FCC Class II Permissive Change Design Change Evaluation – AFIRS 228S Satellite Data Unit (SDU)

p20a0015_FCC C2PC_IB2AFIRS228S0

Subject: FCC Class II Permissive Change Design Change Evaluation – AFIRS 228S
Satellite Data Unit (SDU)

Block diagram of the Modem Control and Interface Module (MCIM)

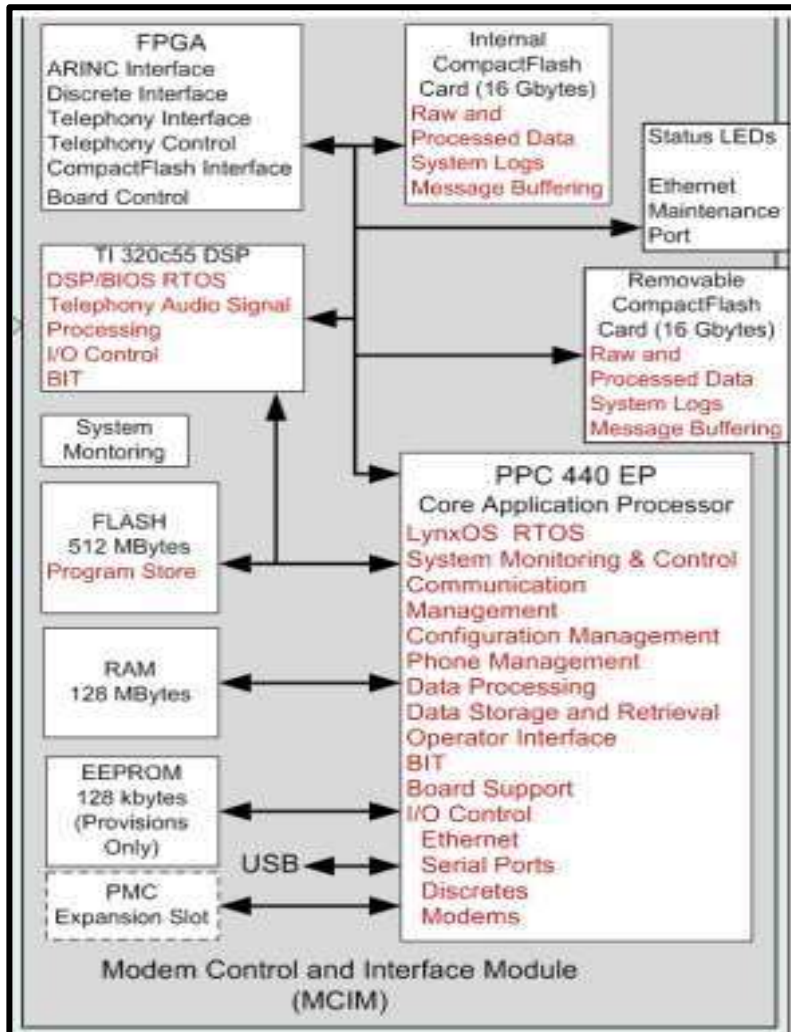
1. The measured Pout and modulation scheme must remain the same. There should be no need to re-do frequency stability, unless there is a fundamental change to how the fundamental is created. Please see KDB 178919 D01 paragraph 1.

2. A technical description is included in Attachment B. The SDU upgrade loaded with SW-20 will continue to comply with the previously FCC certification requirements.
3. A part-by-part comparison between the old and new variant is shown on Attachment B. The SDU upgrade loaded with SW-20 will continue to comply with the previously FCC certification requirements.

SDU Old SLIC Schematics (PNR 502-1300-05)

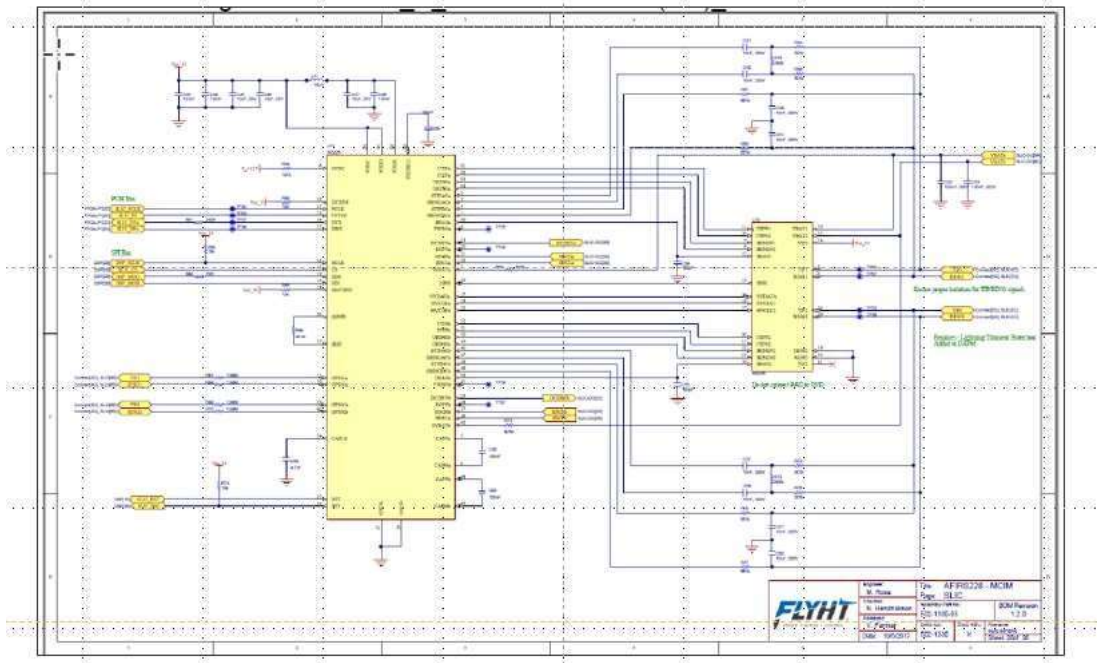
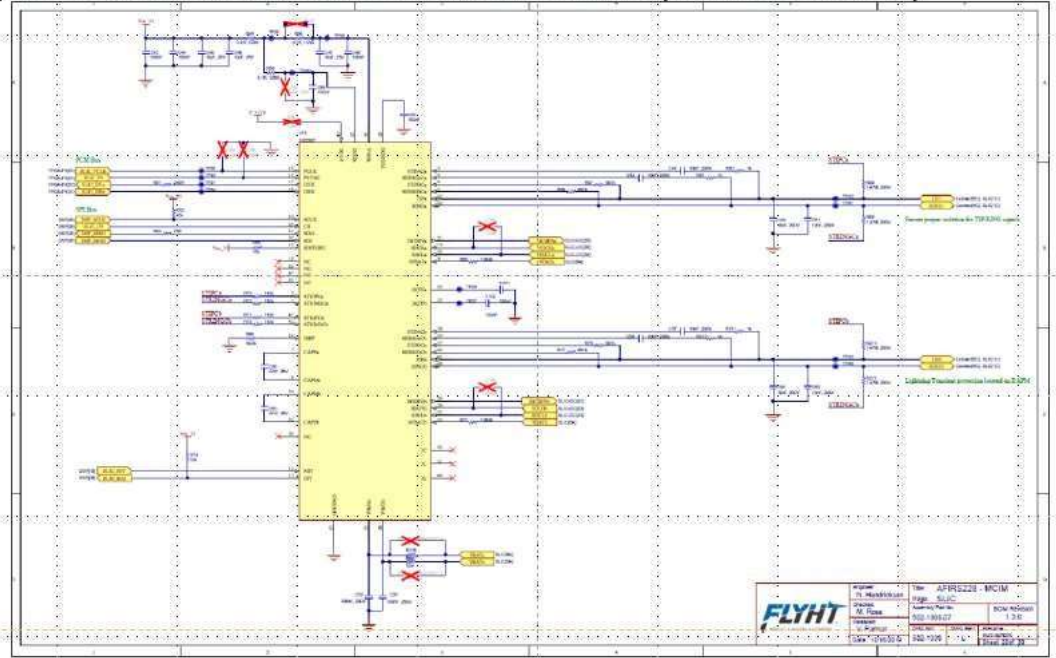
The obsolete SLIC (PNR SI3226-E-GQ) and SLIC driver (PNR SI3208-B-GM) were used on the MCIM CCA (PNR 502-1300-05) to provide two SLIC channels. A new combined SLIC/Driver (PNR SI32287-A-GM) is used on the re-spun MCIM CCA (PNR 502-1300-07) to replace these obsolete SLIC parts and provides a dual-function for two SLIC TIP and RING channels.
